**RE: Winrock Town Center Park
2100 Louisiana Blvd.
Drainage Report Stamp Date: 1/17/2022
Hydrology File: J19D058G**

RE: Winrock Submittal Review

WINROCK TOWN CENTER DRAINAGE IMPLEMENTATION PLAN AMENDMENT 1

**CITY OF ALBUQUERQUE
DRB PROJECT NO. PR2018-001579**

EXHIBIT 4

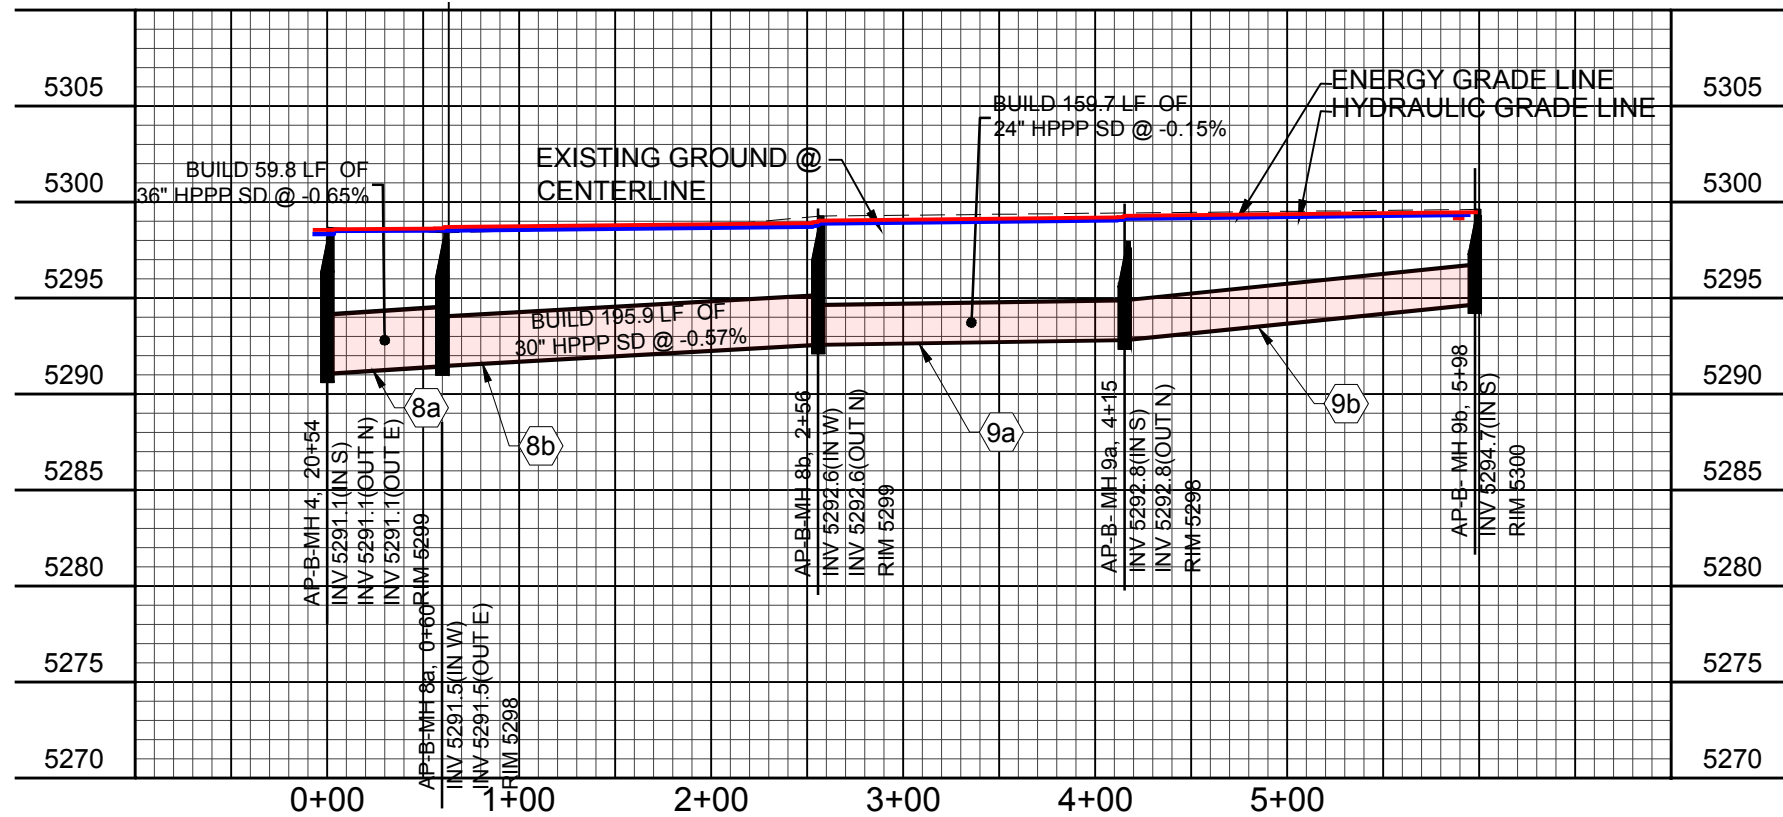
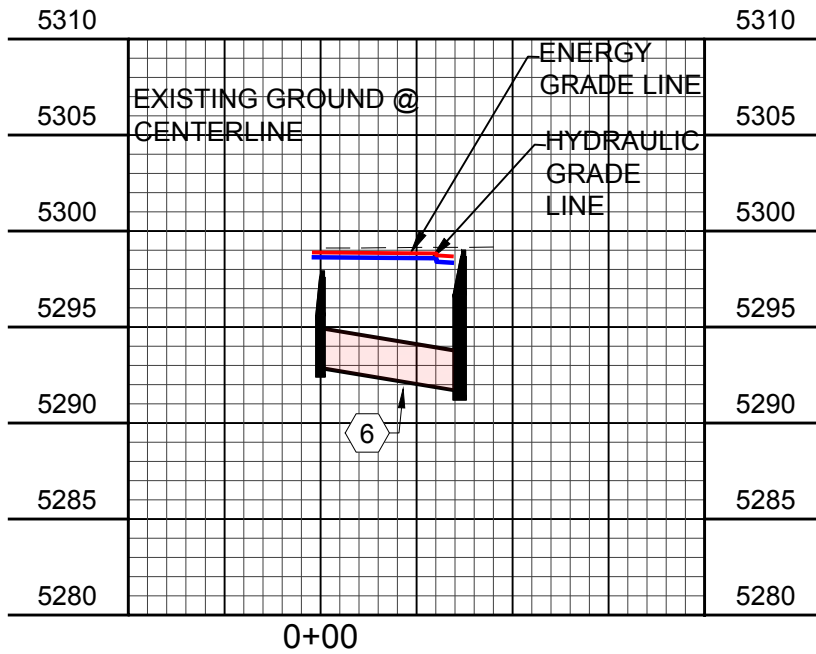
Comment # 3: On Exhibit 4 the profile of Storm Drain AP-B 500 only the surface, EGL and HGL are shown, there is no storm drain line shown.

- The storm drain is now visible.
